APPEAL SUMMARY

Appeal ID: 24644	Project Address: 8435 NE Glisan St
Hearing Date: 2/24/21	Appellant Name: Jason Olson
Case No.: B-008	Appellant Phone: 360-694-8571
Appeal Type: Building	Plans Examiner/Inspector: John Cooley
Project Type: commercial	Stories: 2 Occupancy: B Construction Type: III-B
Building/Business Name: Mitchell Library - Multnomah University	Fire Sprinklers: Yes - Existing in Halls, Proposed in Laboratories
Appeal Involves: Alteration of an existing structure	LUR or Permit Application No.:
Plan Submitted Option: pdf [File 1]	Proposed use: Educational Laboratories

MU - Science Labs

APPEALS SET

1 LEVEL 1 - LIFE SAFETY PLAN
SCALE: 1/8" = 1'-0"

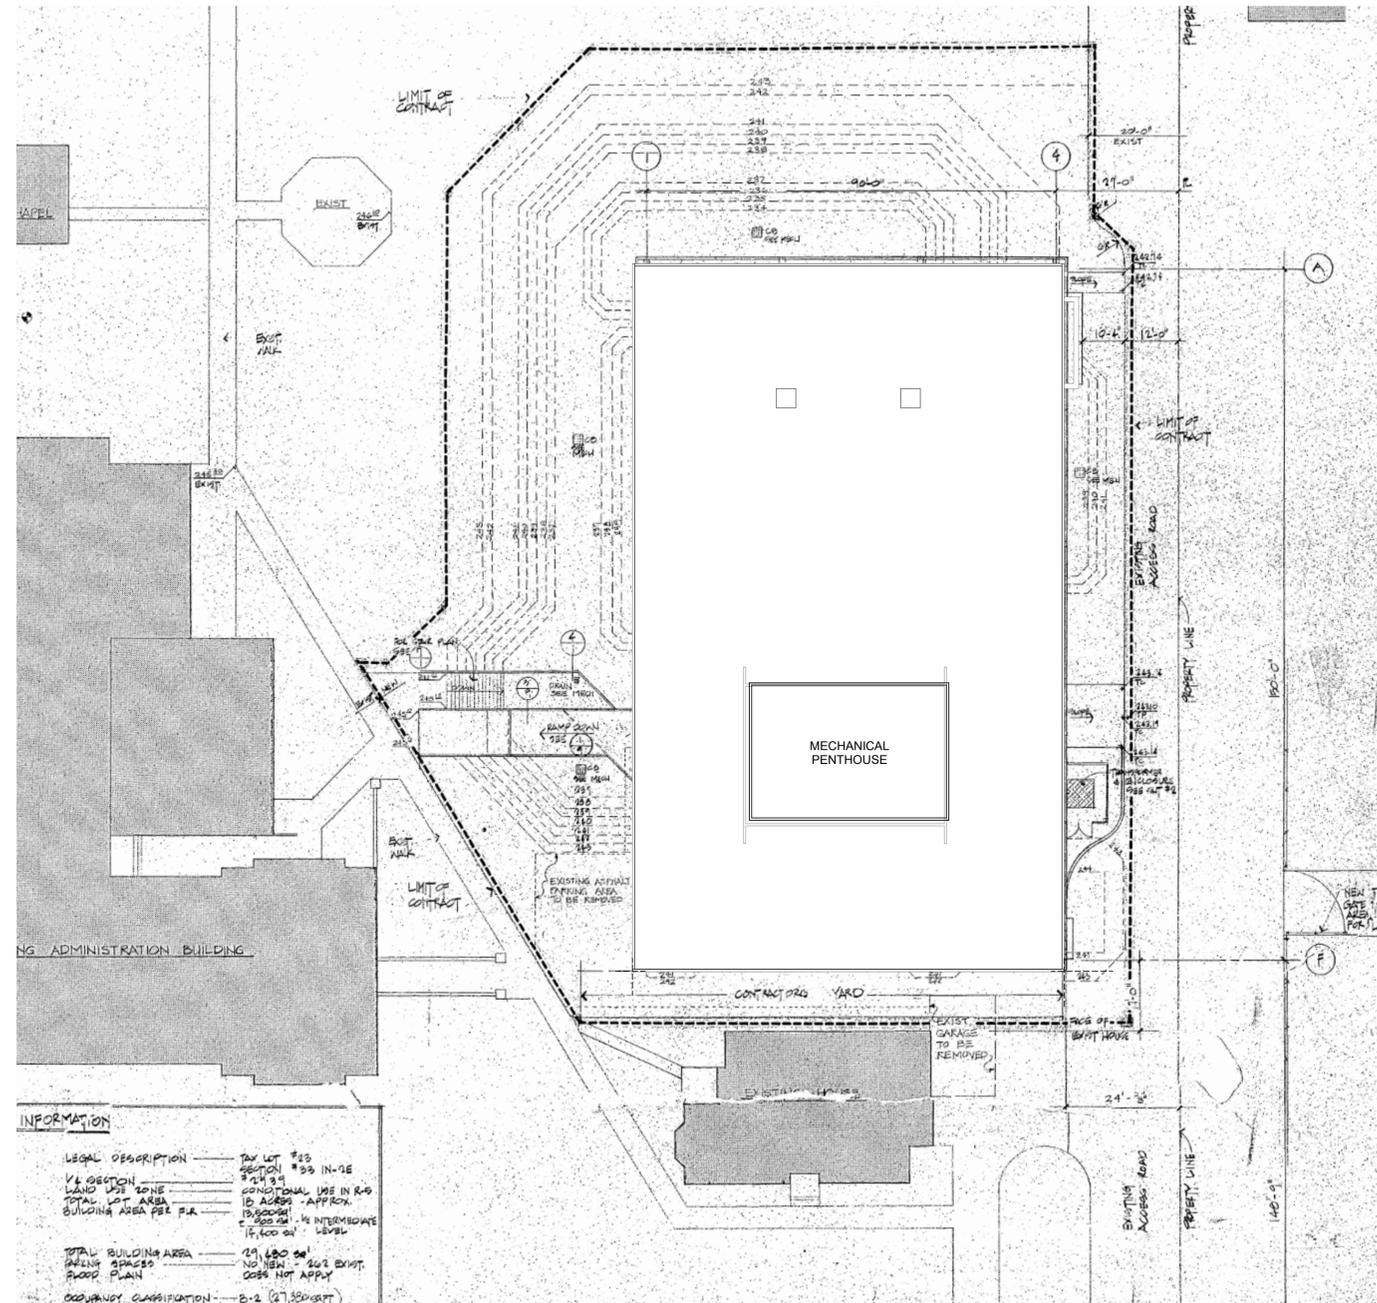
Proposed Design The proposed area of assisted rescue for the project scope is located between Grids 1 and 2, along Grid F. The adjacent exterior wall meets the requirements of OSSC 1009.7.2. but is penetrated by two exit-only doors that include relites and sidelites within the 10 foot horizontal distance from the proposed area of assisted rescue. An automatic fire extinguishing system is proposed to provide sprinklering the doors and windows as an alternate to OSS 1009.7.2 requirements.

2. Type 13 water curtain sprinkler protection at non-fire rated openings in one hour wall at exterior area of rescue assistance: Granted provided

windows are non-operable, fixed glazing doors are on closers and sprinklers are spaced not more than 6 feet apart and placed a minimum of 6 inches and a maximum of 12 inches from the opening(s) and a maximum of 12 inches below the ceiling. Sprinklers are to be installed on the occupied side of the openings. A separate permit from the Fire Marshal's Office is required.
